U.S. Forest Service – Monongahela and George Washington National Forests

Date/Time: Monday, November 21, 2016 @ 10:30am-12:30pm (Eastern)

Background

The primary purpose of the meeting was for Atlantic Coast Pipeline (ACP) to present and solicit Forest Service feedback on ACP's proposed *Best in Class (BIC) Steep Slopes Program as well as demonstrating how this would be applied to steep slopes in the National Forests*. The accompanying presentation and materials were distributed to Forest Service staff prior to or during the meeting. The notes summarize discussion and content not reflected in the accompanying materials.

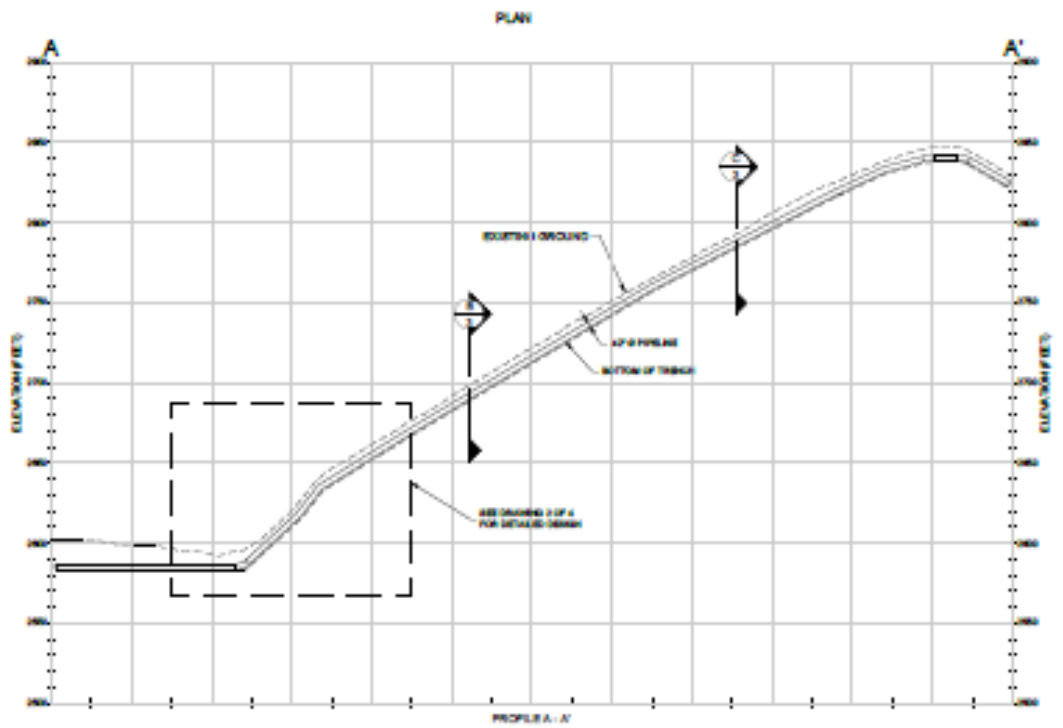
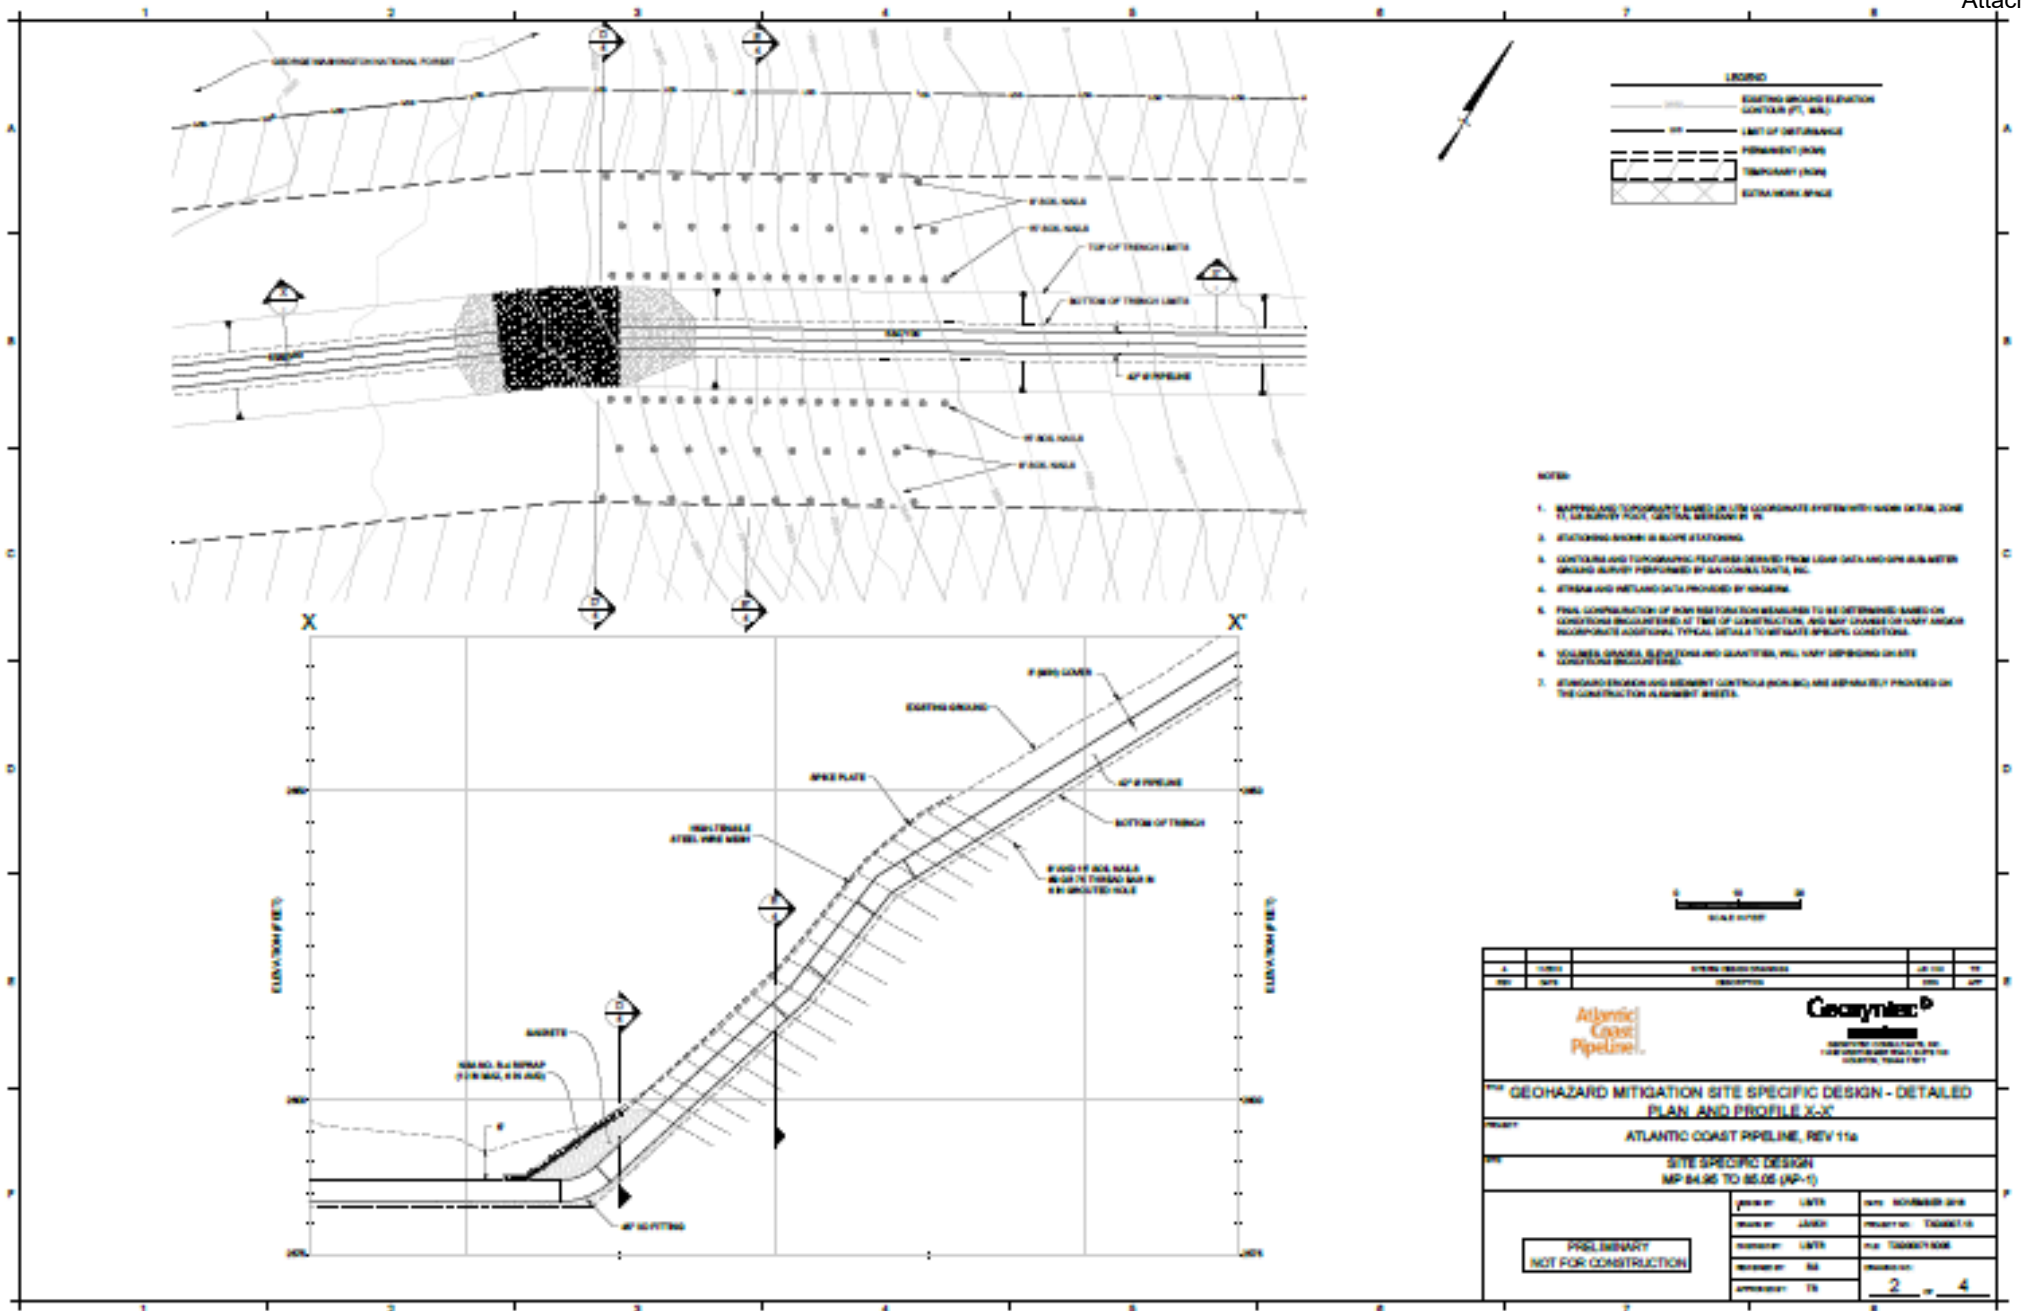
Tom C. said the alignment shows the square footage for temporary work space (TWS), but on plan view drawing, the TWS is on the top of the ridge. On the Monongahela National Forest and GWJ there was no cross section on the TWS. The FS wants to see a cross section and profile of the TWS.

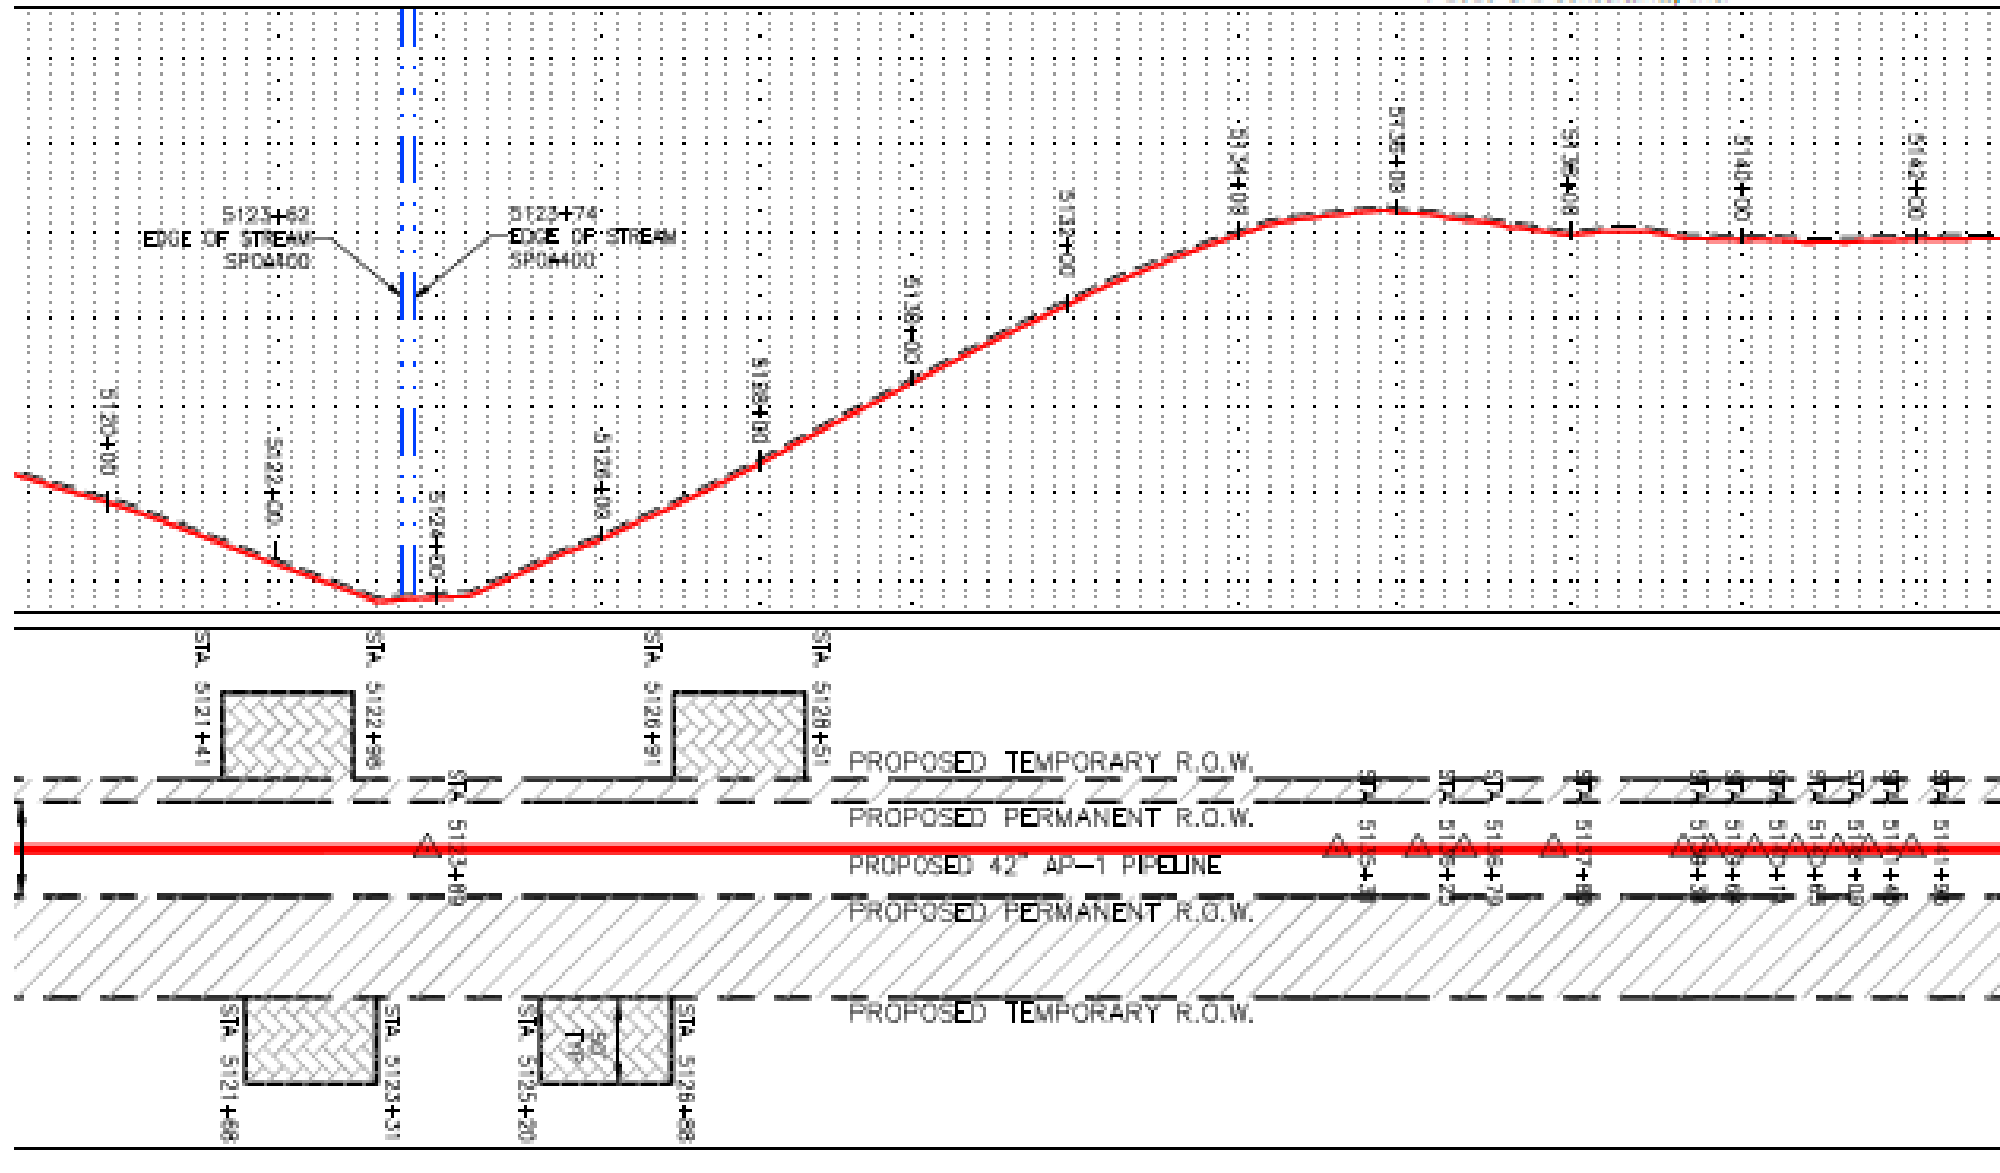
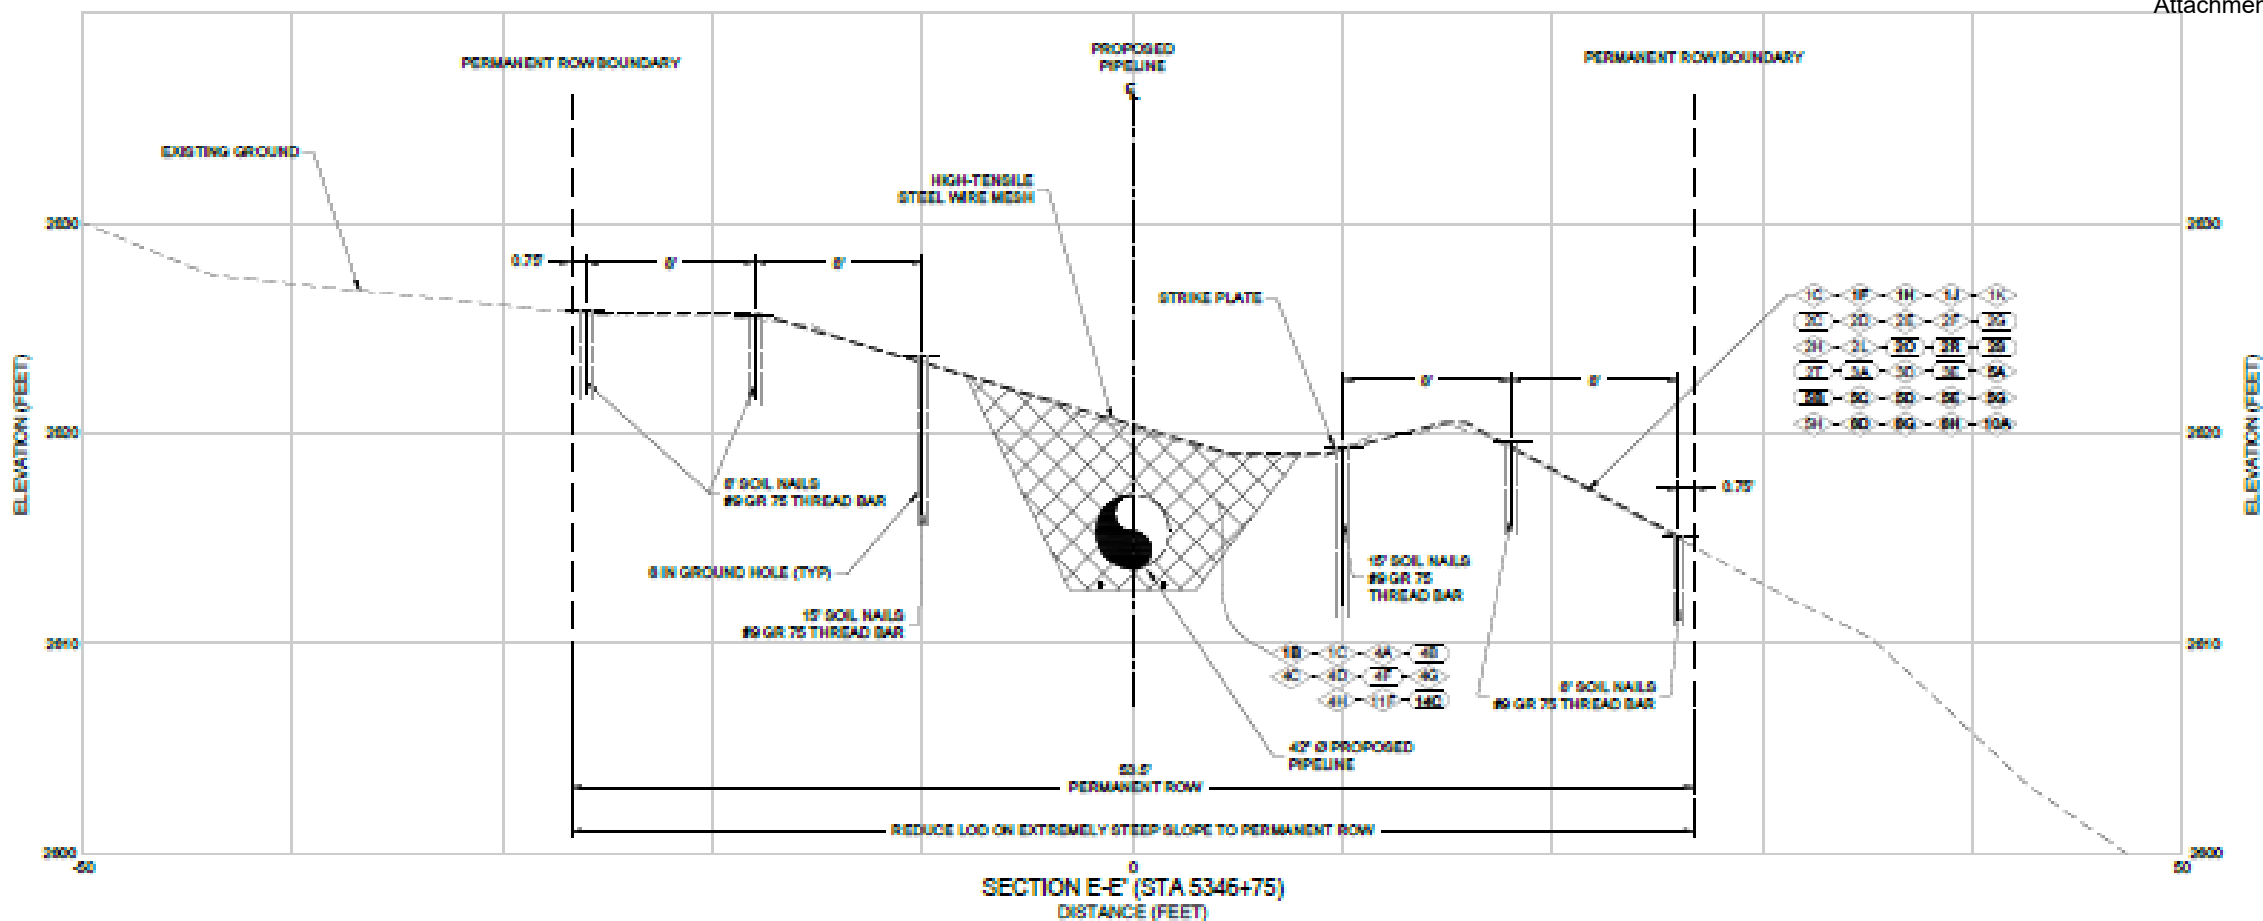
Tom C- from alignment shows the TWS is at the bottom not the top. Action- ACP provides most recent alignment.

PLAN

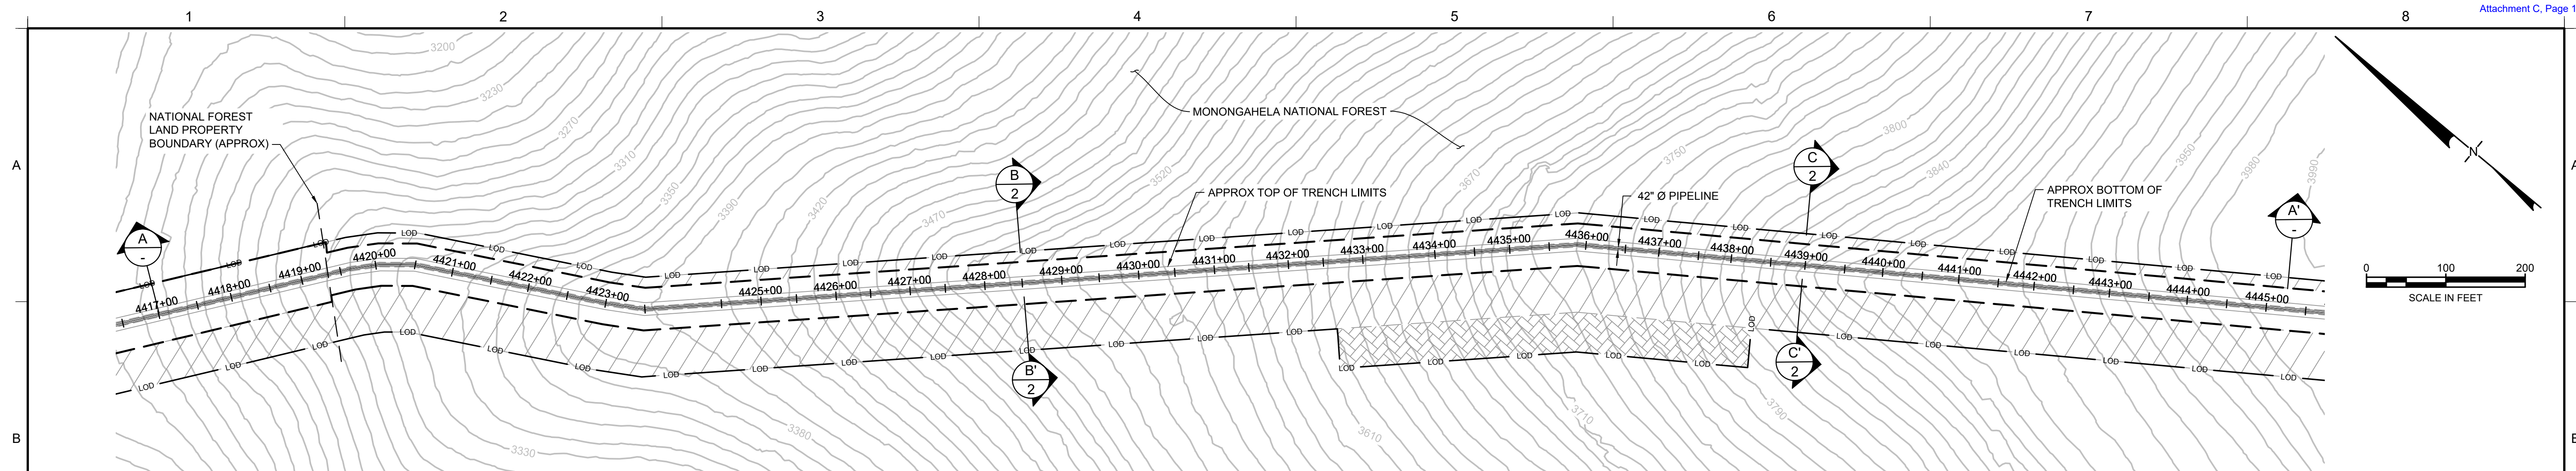
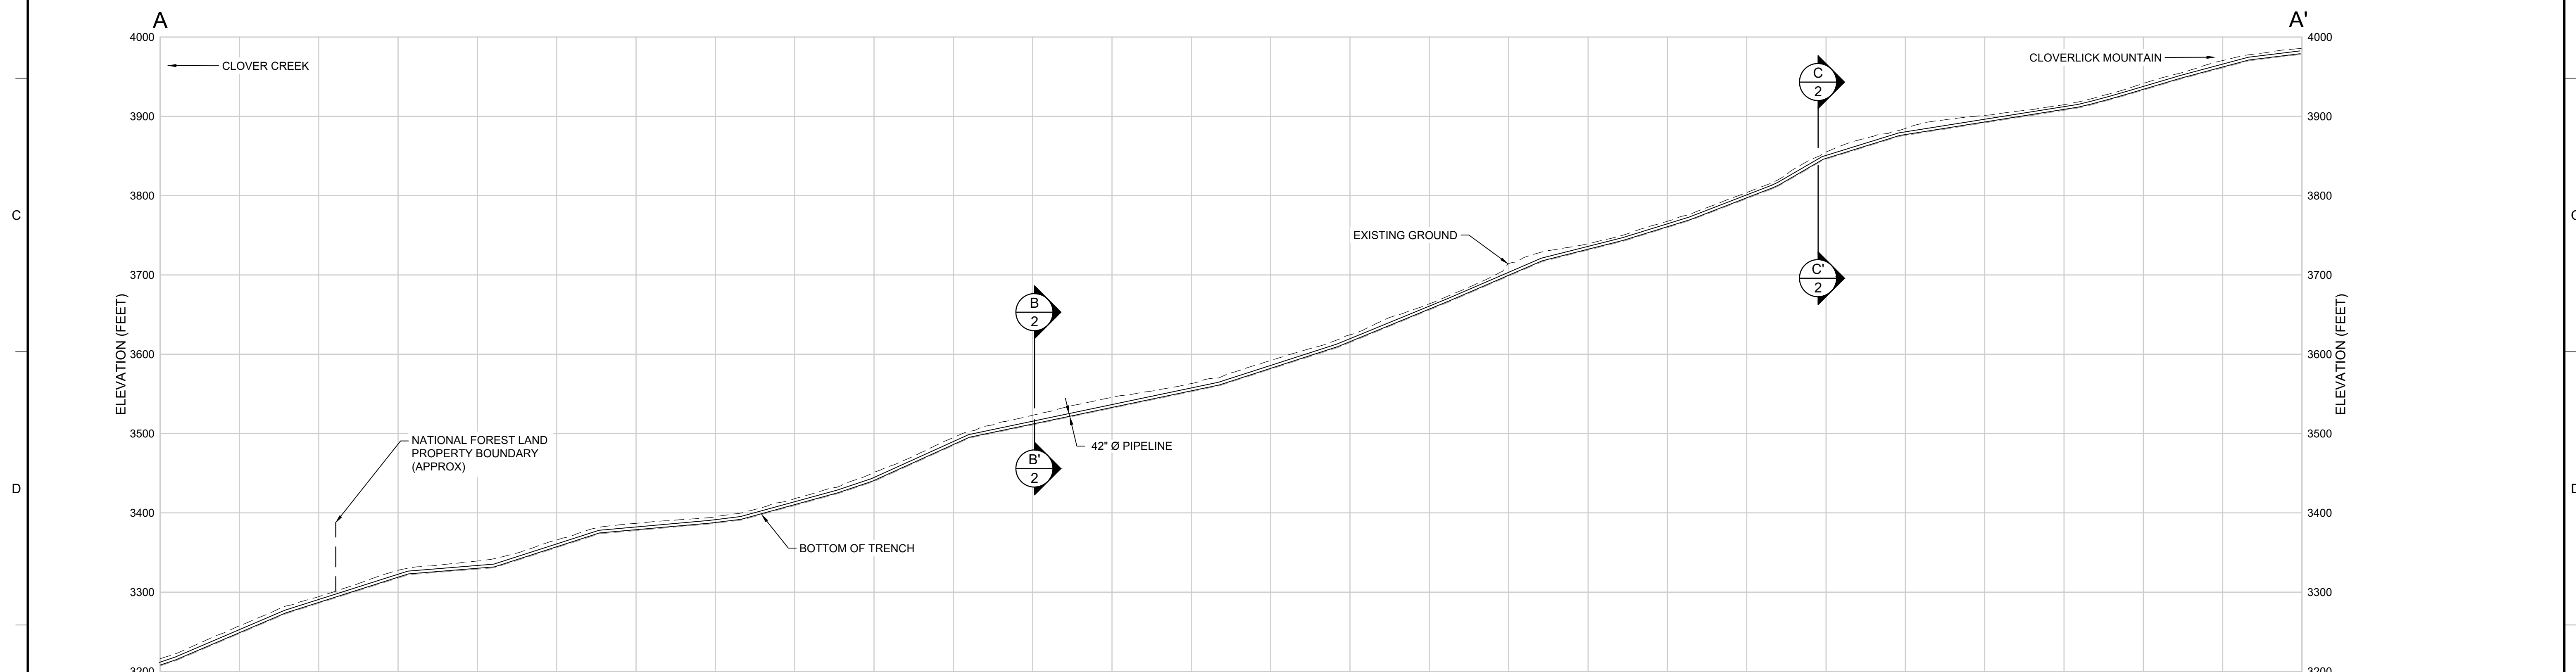
- “Proposed pipeline” changed to “pipeline” on centerline label and pipeline label.
- Dimensions of ditch spoils piles reduced.
- Additional axes labels added to the horizontal offset distances on the sections.
